Final Report - Corrections Required **Application No. ANEX-24-0007**

Description : Matrix Design Group on behalf of Colorado Springs Equities LLC is submitting a serial annexation petition for seven parcels and Land Use Plan/Rezoning exhibit for a portion of the subdivision known as Rock Creek Mesa.

ANNEXATION PLAT

ROCK CREEK MESA ADDITION NO. 7

SHEET 1 OF 2

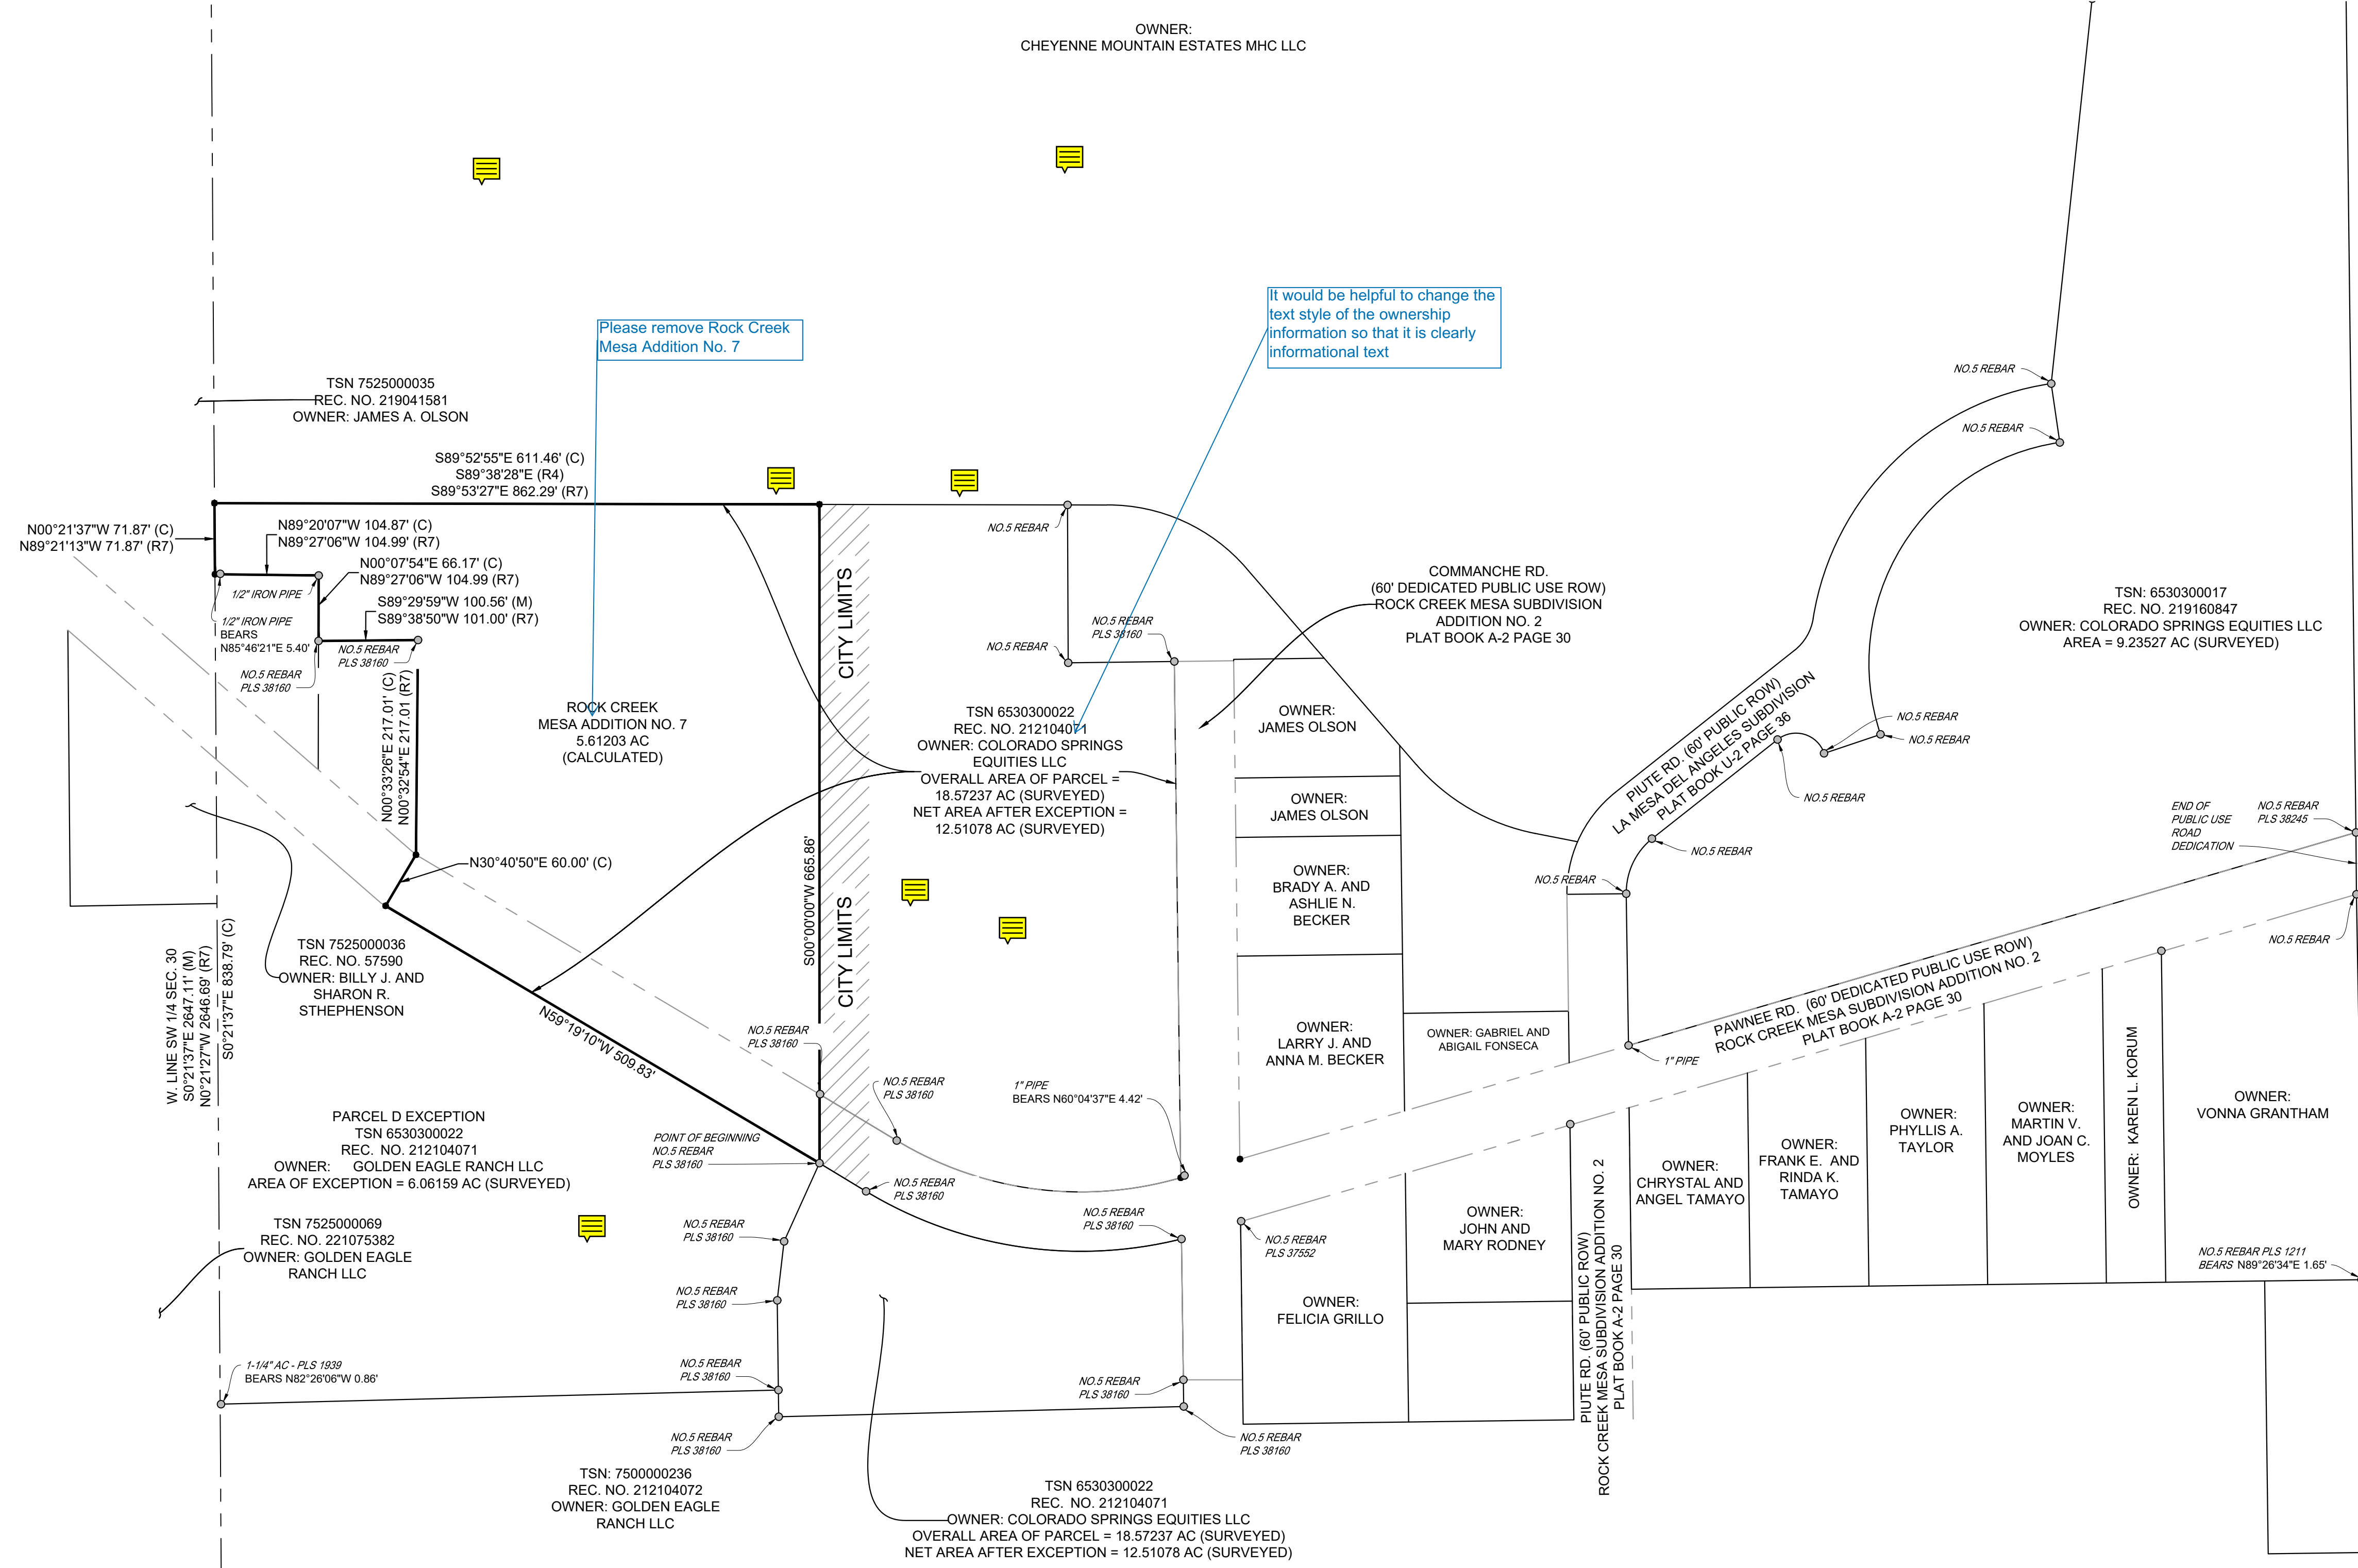
Please acknowledge the following:
Informational Items:
On February 14, 2023, Colorado Springs City Council approved a water service extension ordinance #23-02 (see attached), City Code section 12.4.305, which directly impacts the extension of water service outside city limits, including for proposed annexations. Under this section of City Code, the water service boundary can only be extended to include the proposed annexation(s) if the annexation(s) meet an exception(s) specified in the ordinance. Descriptions and application of each exception(s) are provided below.

Please acknowledge the following Water Planning Informational Note:
Please refer to the completed Hydraulic Analysis Report completed on November 2, 2023 for HR Green and SSS Education. Conclusions and Requirements:
**Modeled fire flows are 2100 to 2200 GPM. No fire flow requirement was provided.
**Either alternative presented in this report are acceptable.
**Since all pressures are below 170 psi, PVC is acceptable.

Please add the area at the end of the legal description

Please respond to LBS comment:
Have reviewed and entered geometry into FIMS.
"Please add detail to the Point of Beginning, such as a tie to a parcel or aliquot corner."

Update to ANEX-24-0007 on each sheet

PREPARED BY: Excellence by Design	ROCK CREEK MESA ADDITION NO. 7 LOCATED IN SECTION 30, TOWNSHIP 15 SOUTH, RANGE 66 WEST OF THE 6TH P.M., COUNTY OF EL PASO, STATE OF COLORADO.		
	CHECKED BY: JRB	SCALE: 1"=100' SHEET 2 OF 2	DATE ISSUED: JANUARY 3, 2024

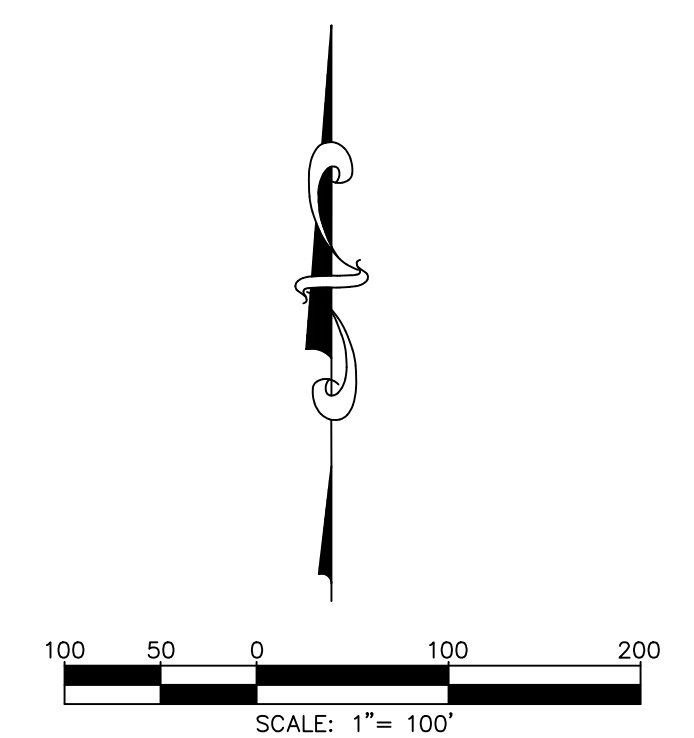
21	224.023-SURV-RCM ANNEX PLAT 7-GRAPHIC 1	Cory Sharp : Planning	Please clearly label the adjacent areas *not a part* for clarity
22	224.023-SURV-RCM ANNEX PLAT 7-GRAPHIC 1	Cory Sharp : Planning	Please clearly depict all of the city limits not just that portion adjacent
23	224.023-SURV-RCM ANNEX PLAT 7-GRAPHIC 1	Cory Sharp : Planning	Please remove the areas from all adjacent parcels
24	224.023-SURV-RCM ANNEX PLAT 7-GRAPHIC 1	Cory Sharp : Planning	Please add labels for the adjacent additions

Comment ID	Page Reference	Reviewer : Department	Review Comments
25	224.023-SURV-RCM ANNEX PLAT 7-GRAPHIC 1	Cory Sharp : Planning	Please remove Rock Creek Mesa Addition No. 7
26	224.023-SURV-RCM ANNEX PLAT 7-GRAPHIC 1	Cory Sharp : Planning	It would be helpful to change the text style of the ownership information so that it is clearly informational text
27	224.023-SURV-RCM ANNEX PLAT 7-GRAPHIC 1	Cory Sharp : Planning	Please add (M) and (C) to the legend
28	224.023-SURV-RCM ANNEX PLAT 7-GRAPHIC 1	Cory Sharp : Planning	It would be easier for review if the adjacent areas were a dashed line type please review and adjust accordingly.
29	224.023-SURV-RCM ANNEX PLAT 7-GRAPHIC 1	Cory Sharp : Planning	Informational: Is it possible to provide the planning department a separate exhibit with all 7 proposed annexations depicted and labeled? Only an informational item? Please coordinate with me if any questions.

30	224.023-SURV-RCM ANNEX PLAT 7-GRAPHIC 1	Cory Sharp : Planning	Please depict and label the basis of bearings and add a tie to the point of beginning so all additions can be tied together

Please remove Rock Creek Mesa Addition No. 7

It would be helpful to change the text style of the ownership information so that it is clearly informational text

Please add (M) and (C) to the legend
